# **EXHIBIT D-1**

## **DRAWINGS AV0001 – AV6103**

**RFP No. 901516 – East County Hall  
of Justice BDA & DAS**

EAST COUNTY HALL OF JUSTICE

1 AV SYSTEM FUNCTIONAL SCHEMATIC – (TRIAL) COURTROOMS (ROOMS 2A207, 3A307, 3A358, 3B311, 4A407, 4A458, 4B411, 4B462, 5A507, 5A558, 5B512 & 5B562)

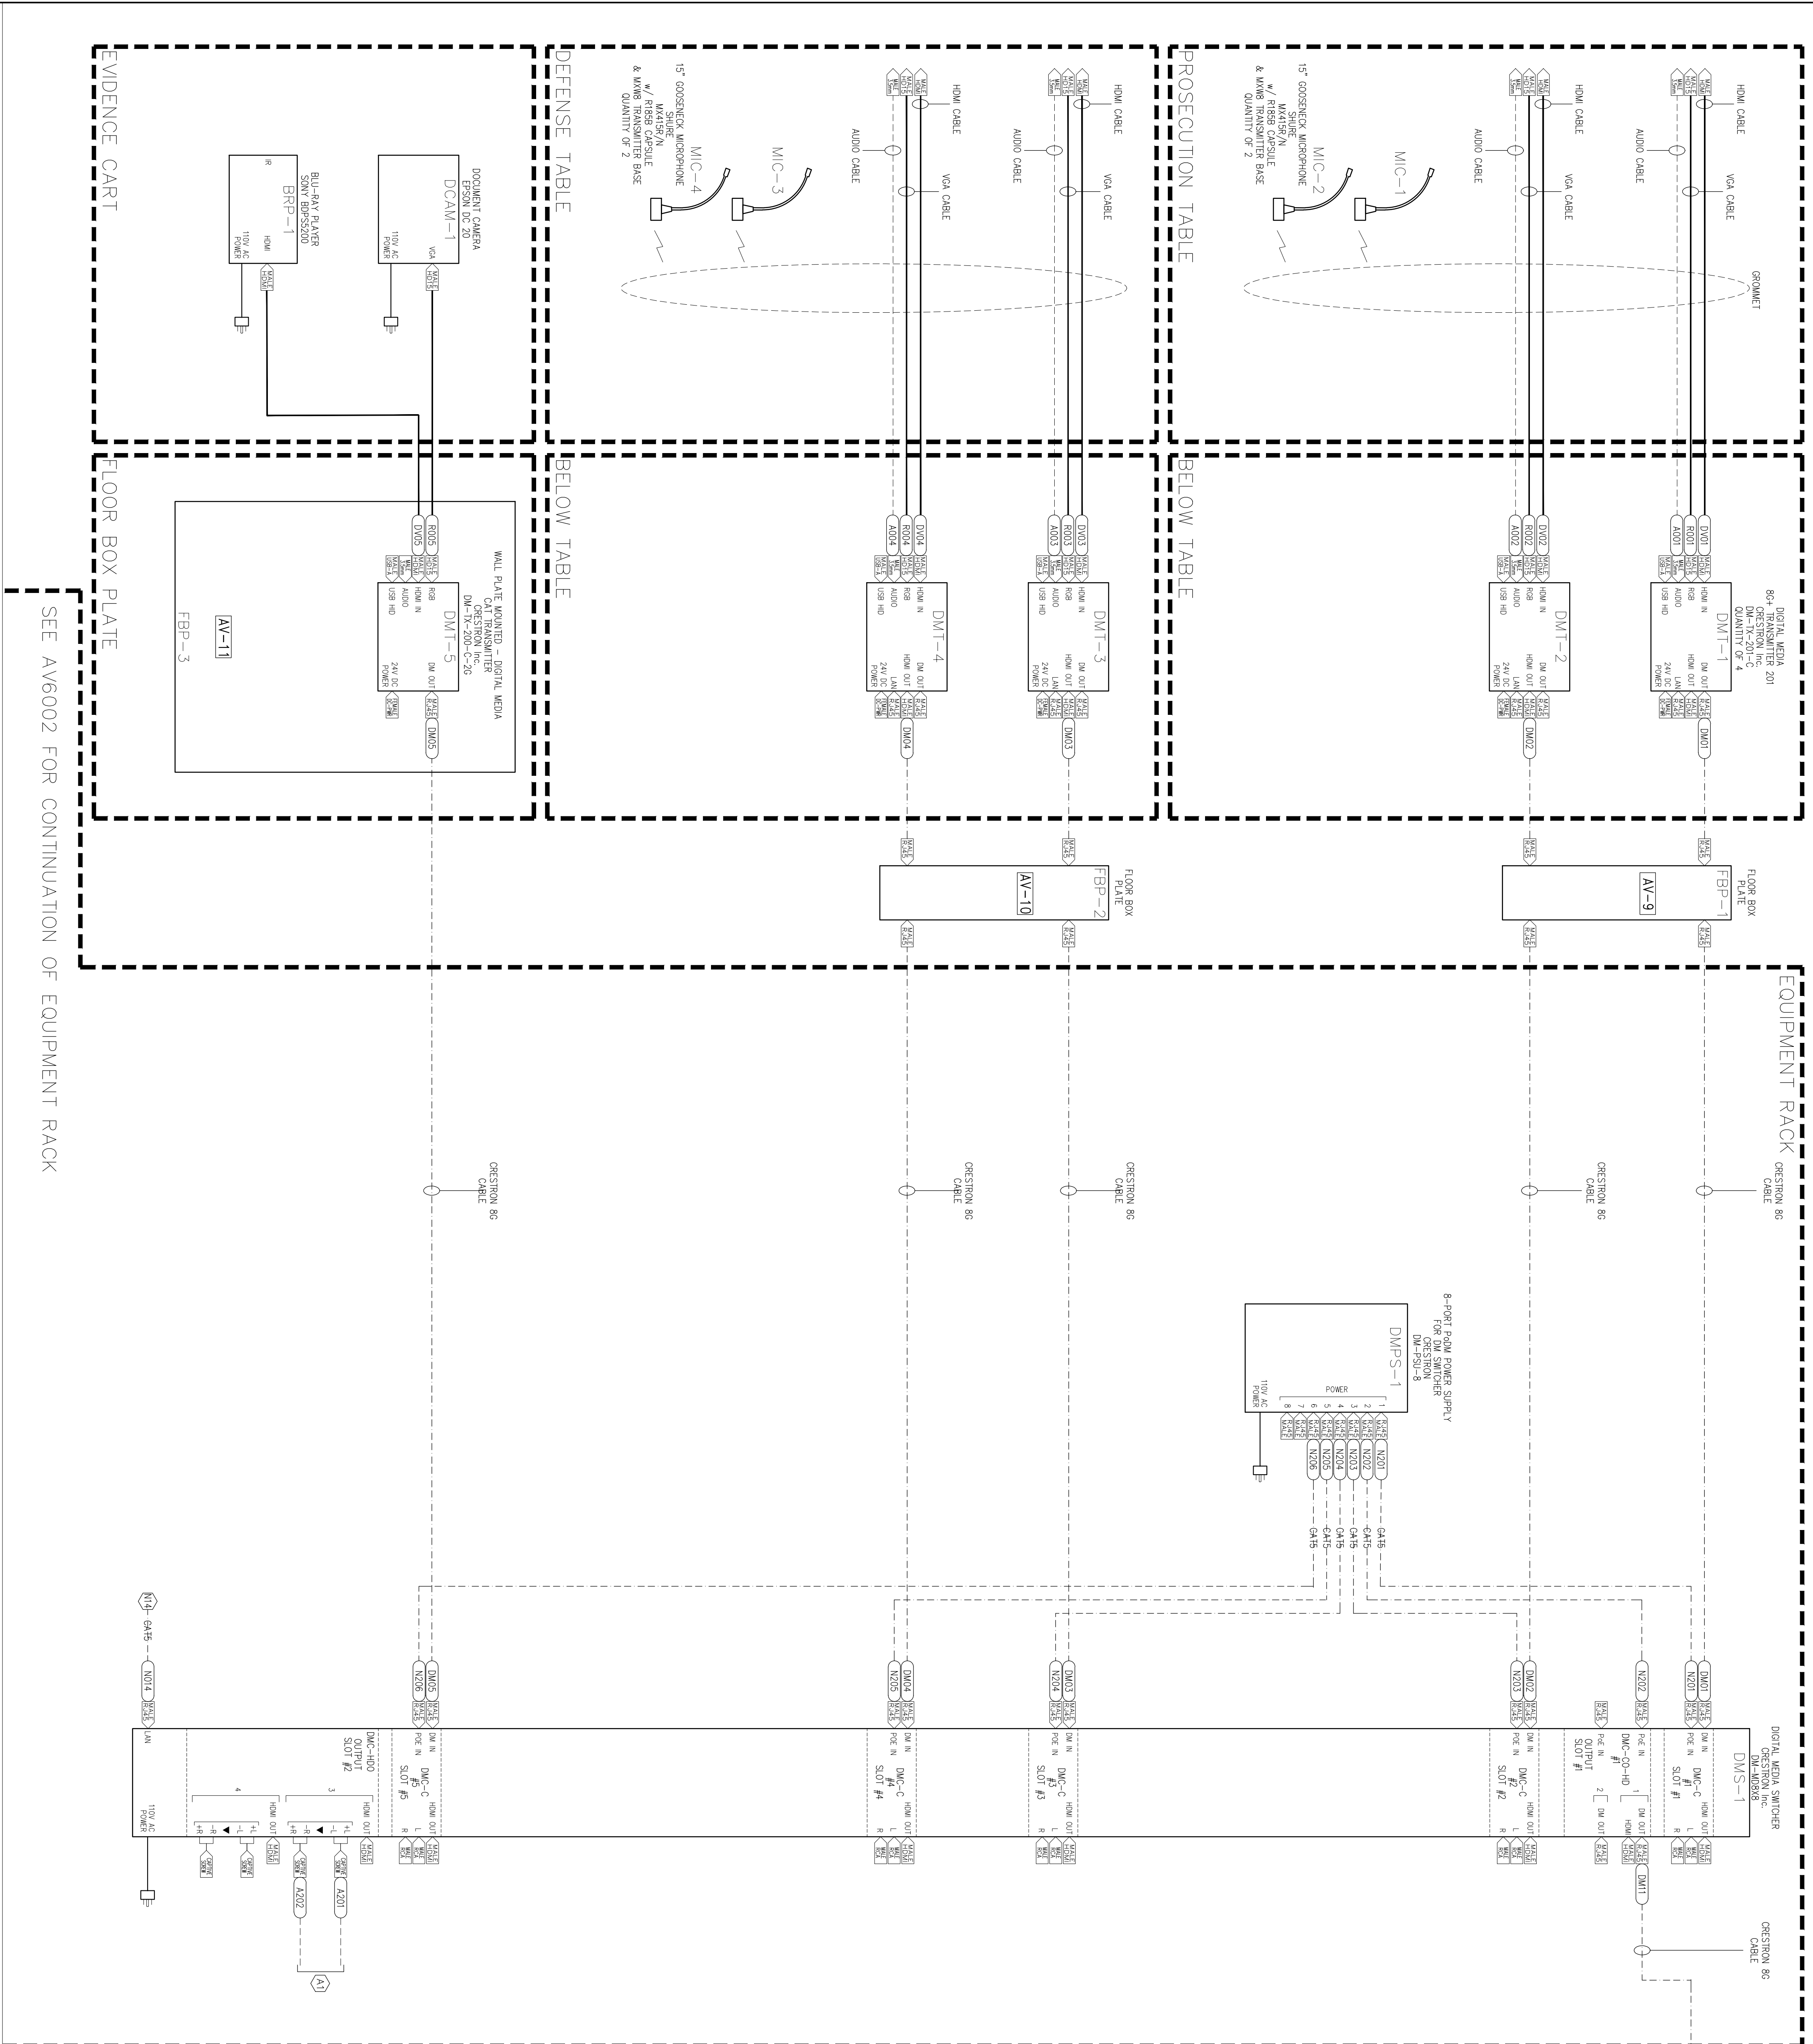
As part of the remaining AV Stakeholders Comments the following comment was provided:

- Touch screens for use between Judge and clear for projector access is to be wireless.

**Revisions have been made to AV Stakeholders RFI 5207 was distributed:**

- In the Courtrooms, the court reporter will not have sidebars for stenotyping.
- Delete one wired touchscreen from each Courtroom bench so only one wired touchscreen will remain.
- Install infrastructure only for overflow capability from Courtroom 3A358 to Jury Assembly Room 2B277.
- Install empty conduit from J-Box up to the ceiling.

1. Confirmed. It is acceptable to change the projector and screen to a 70" monitor in Conference Room 1A102.
2. Confirmed. It is acceptable to install a projector and screen in room 1B149 as currently shown in the approved AV drawings.
3. Confirmed. It is acceptable to replace the two 70" monitors with one 80" monitor in room 3B351.

DRAWING TITLE  
ARRANGEMENT  
AV SYSTEM FUNCTIONAL SCHEMATIC  
WIRING DIAGRAM  
COURTROOM 2A258  
SHEET NUMBER

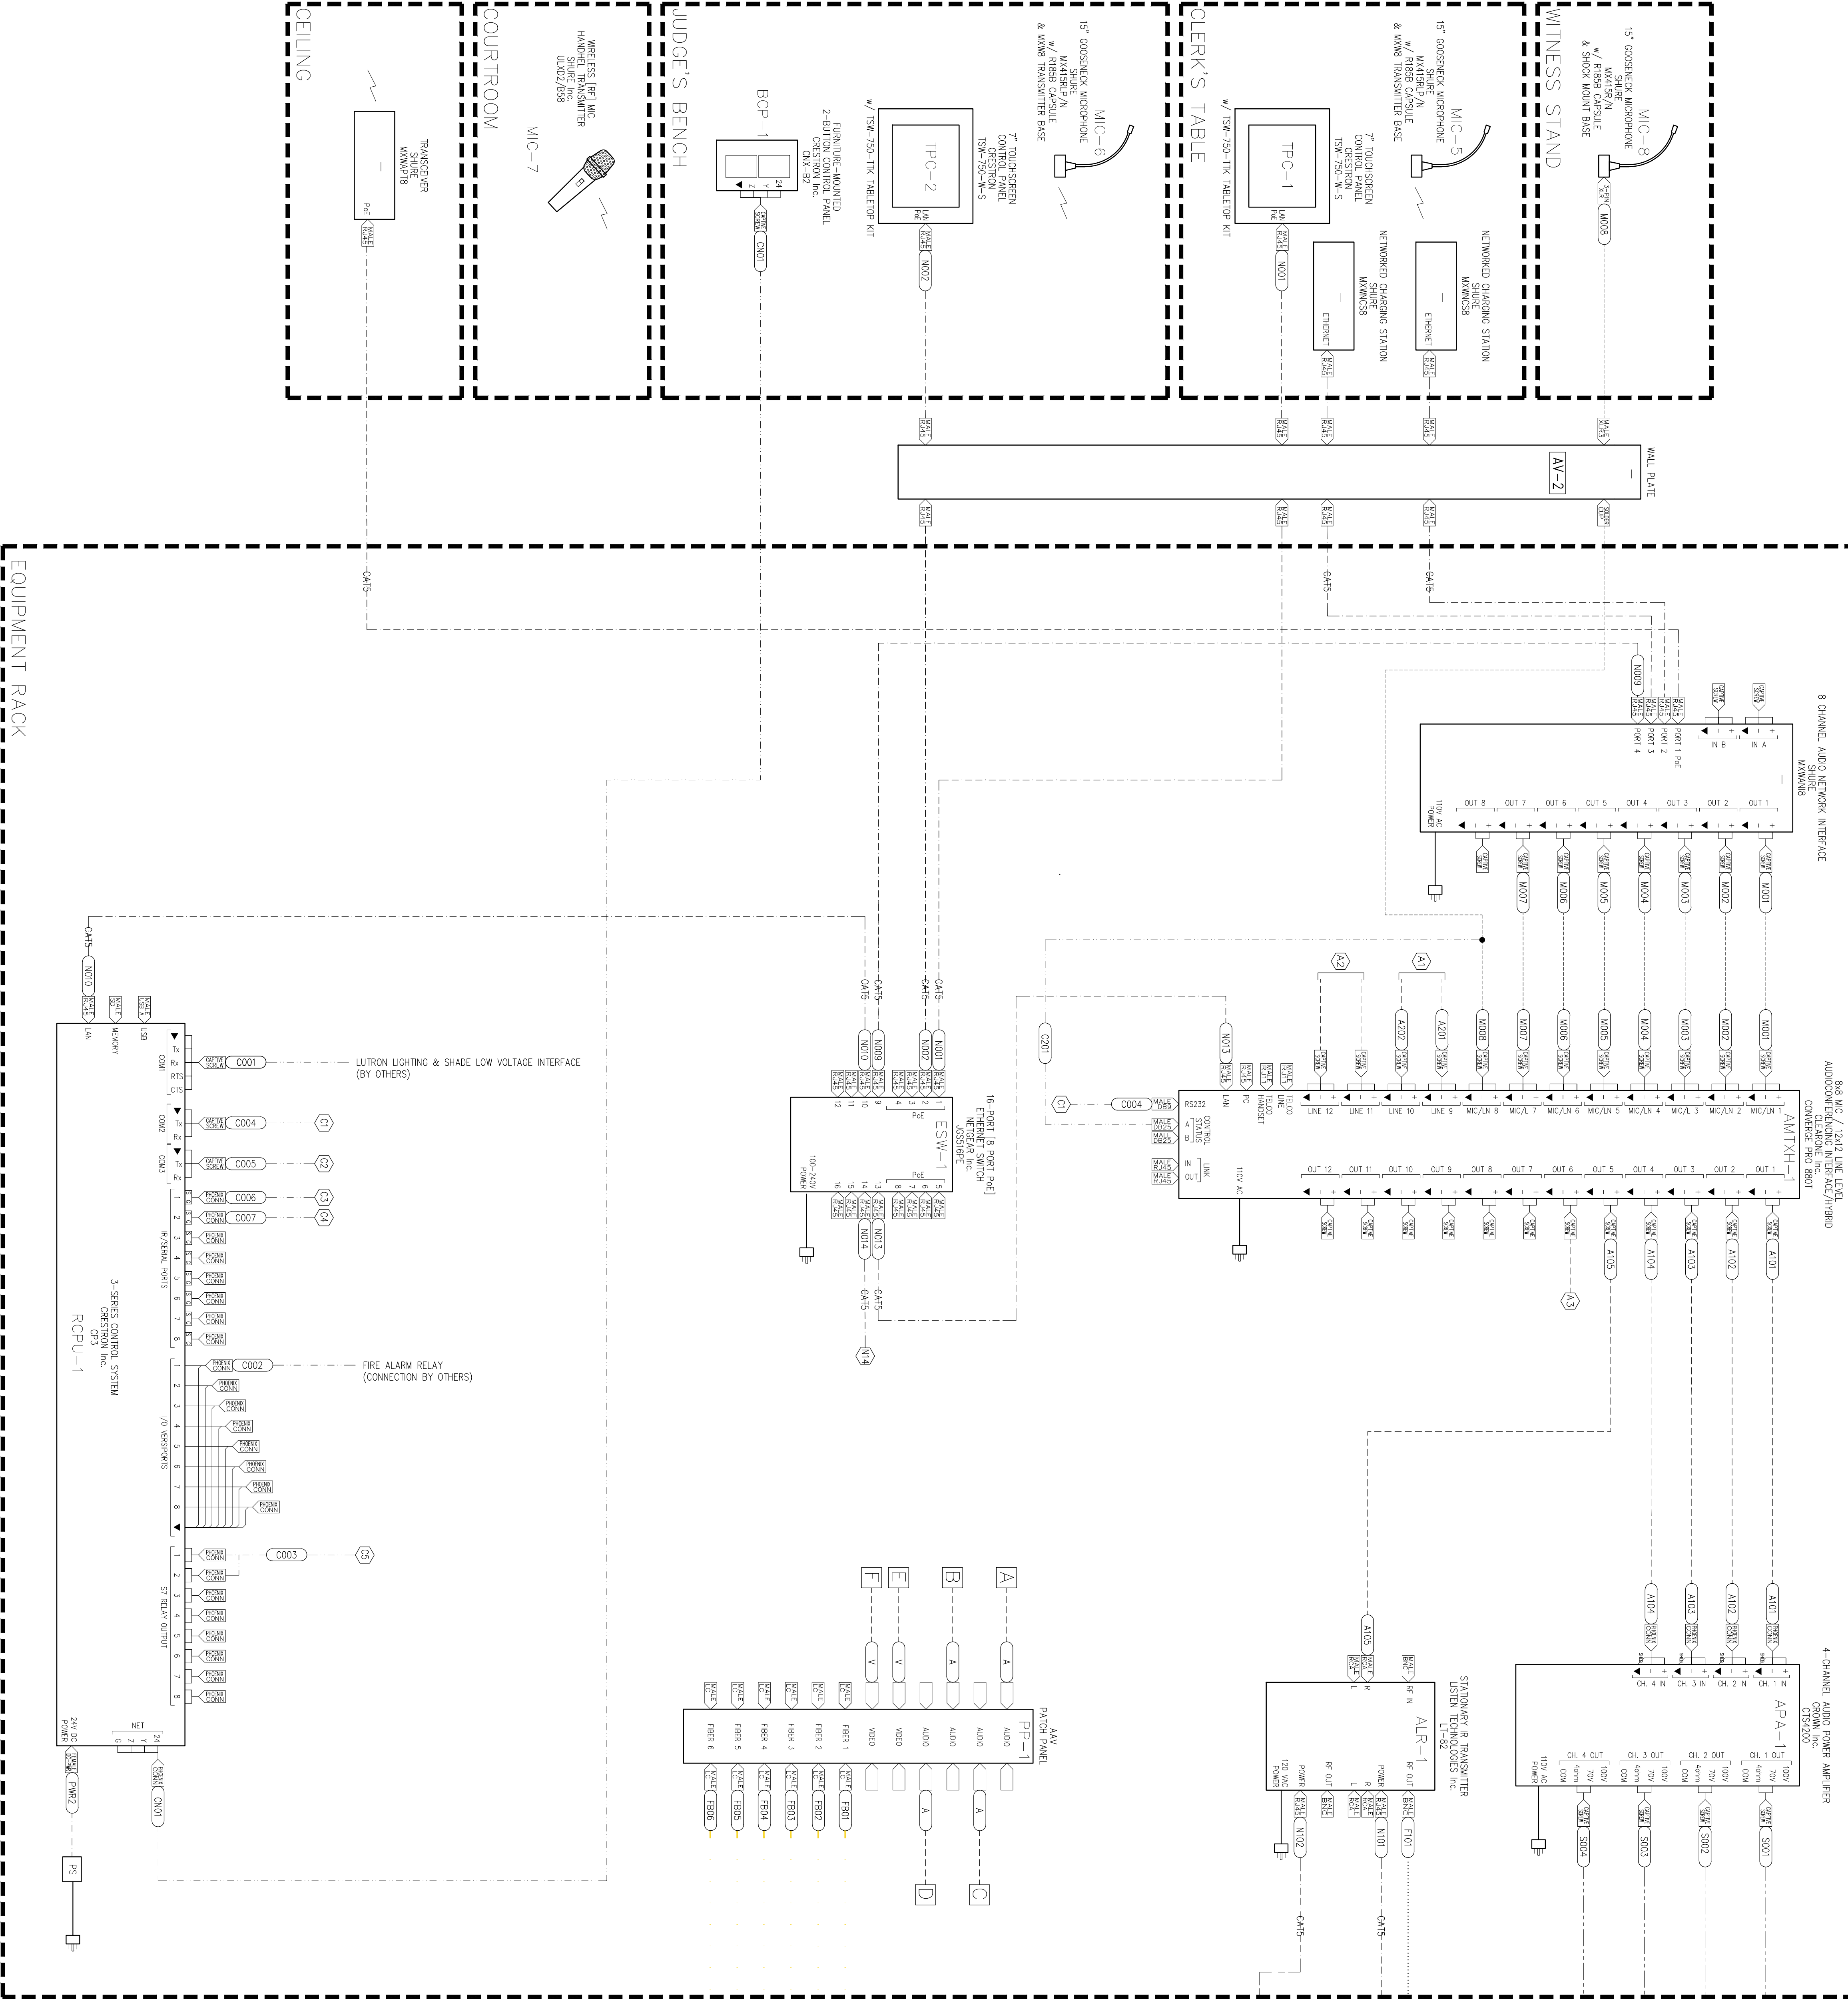
REVISION 5207

As part of the remaining AV Stakeholders Comments the following comment was provided:  
- Touch screens for use between judge and clear for projector access is to be wireless.  
**Revisions have been made to AV Stakeholders Comments the following comment was provided after RFI 5207 was distributed:**  
- In the Courtrooms, the court reporter will not have sidebars for stenotyping.  
- Delete one wired touchscreen from each Courtroom bench so only one wired touchscreen will remain.  
- Install infrastructure only for overflow capability from Courtroom 3A358 to Jury Assembly Room 2B277.  
- install empty conduit from J-Box up to the ceiling.
